# Multiple CPs for 16m downlink OFDM frame structure

IEEE C802.16m-08/644r1

To be discussed and adopted by TGM for the 802.16m SDD.

- Section 11.4.1 (Replace Figure 17 with the following figure)

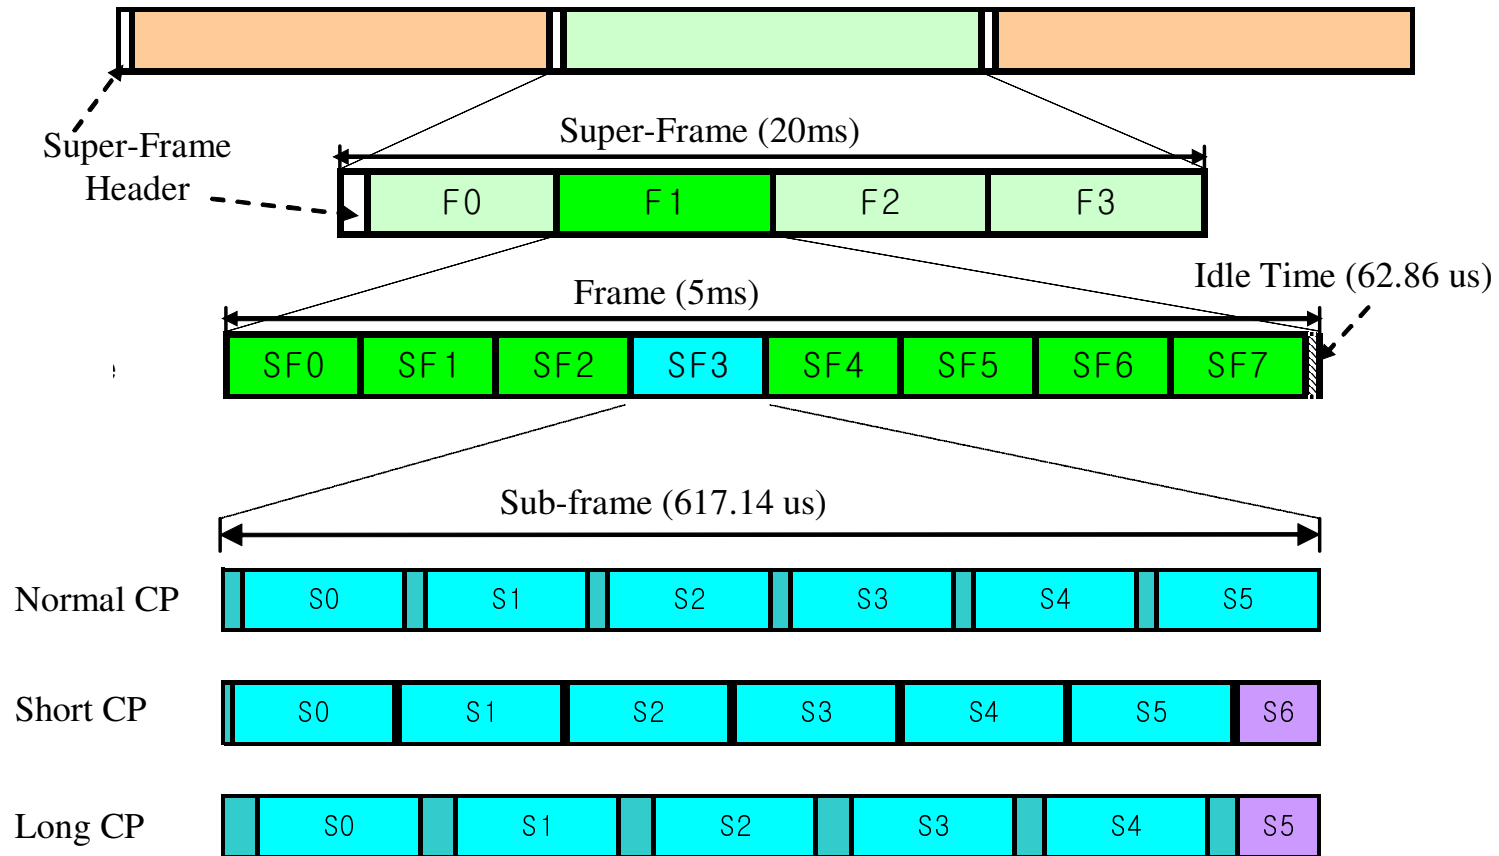
In addition to the full OFDM symbol, the proposed frame structure uses half OFDM symbol that consists of a CP with the same size and the useful symbol part with half the size of those of the full OFDM symbol, respectively. The proposed frame structure supports three different CP sizes: Short, Normal and Long.
